# Purchase College

## IFB SU-112020 Central 5 Parking Lot ADA Asphalt Addendum #1 \* January 6, 2021

SUNY Purchase wishes to make the following clarification to IFB SU-112020.

SIDEWALK AND CURB RAMP DETAILS  
(SHEET 3 OF 9)

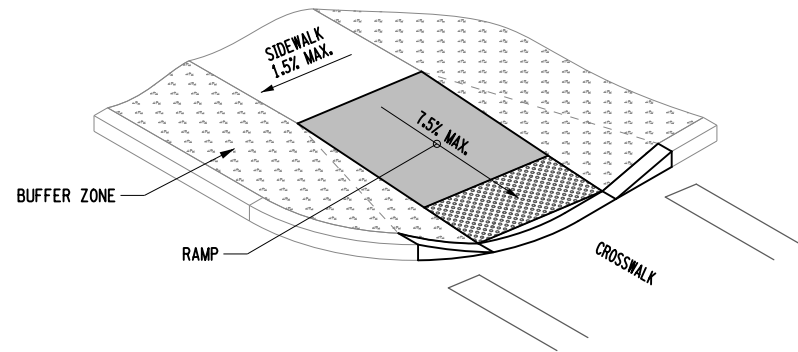
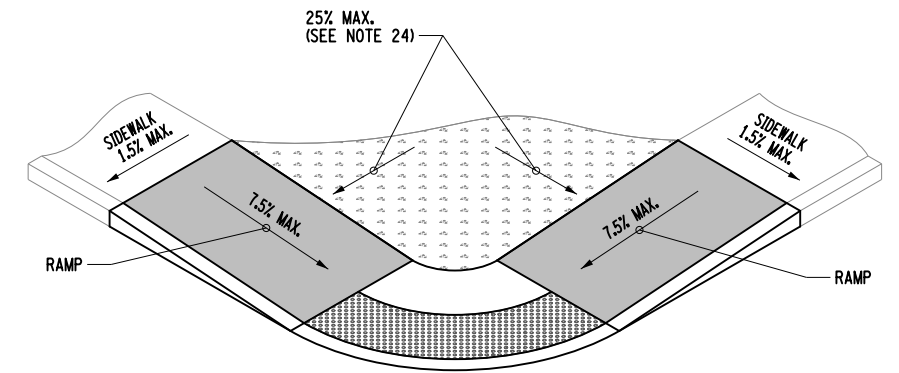
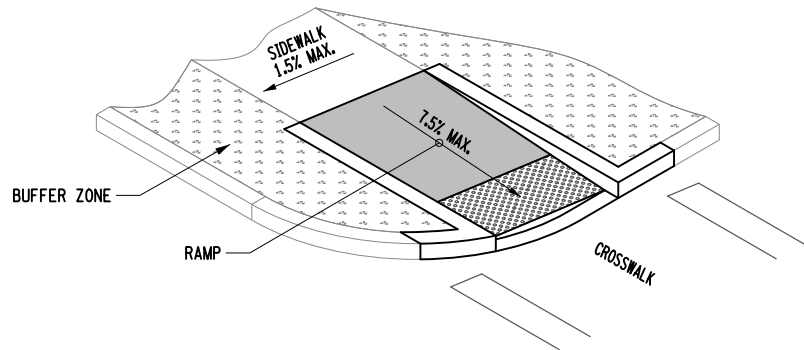
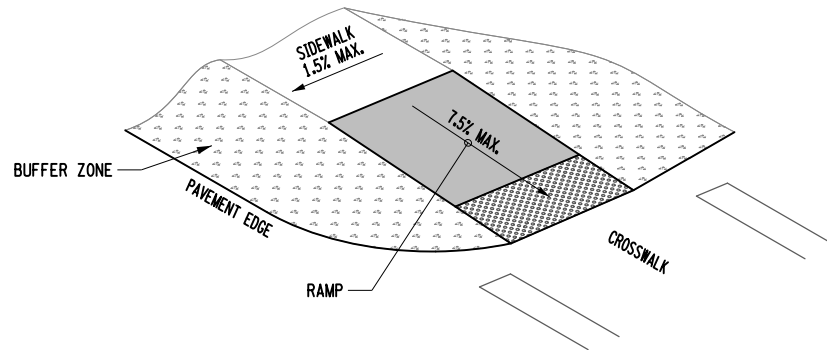
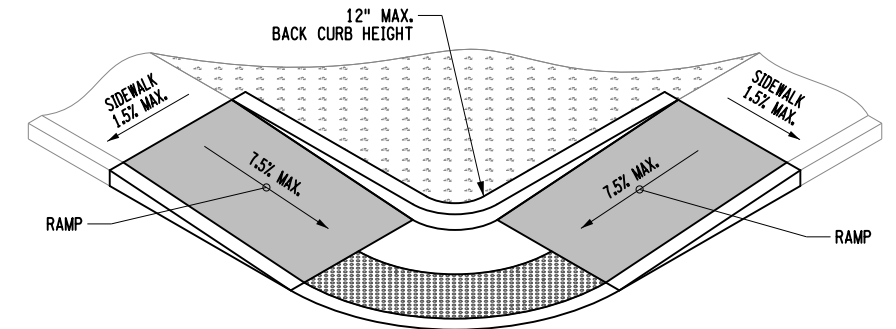
4. Q: Please provide sketch of curb cuts to be made.  
A: There is no sketch of the actual curb cuts available. However they need to be ADA compliant and follow the ADA guidelines. Since this is asphalt and not concrete, there will be a graded earth type of transition. Side flares will be graded earth. The new asphalt should slope down to the ADA hatched area in the parking lots, with the detectable warning strips installed across the full width of the path at the transition point. The path sloping down to the parking lot must meet the same percentages. See attached NYDOT diagram for reference.
